## Latest Track Tweaks—Stiffen centre section, Spring pans

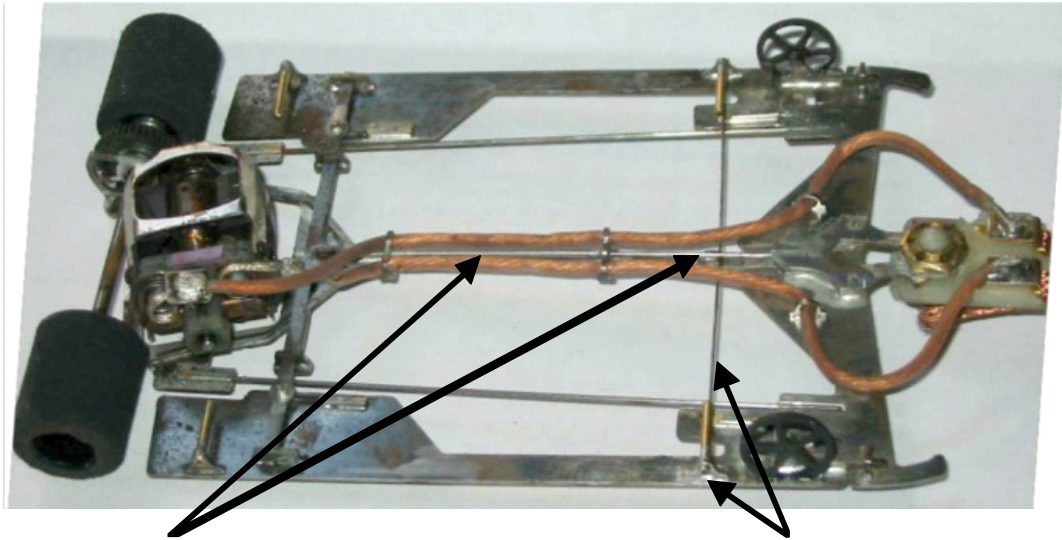
New versions of this chassis now feature a 0.047 centre rail, solder this at the back and also to the two lead wire retainers and the rear of the guide plate. It is also advised to use stainless steel pin tube in the pin mounts.

Cut slots in the underside of both front pin tube mounts so you can slide a piece of 0.015" piano wire under the centre section wire and into the mounts above the pan and below the pin tube. Solder wire to pin tube mounts & tag wire to centre section to "spring pans" lightly in forward position.
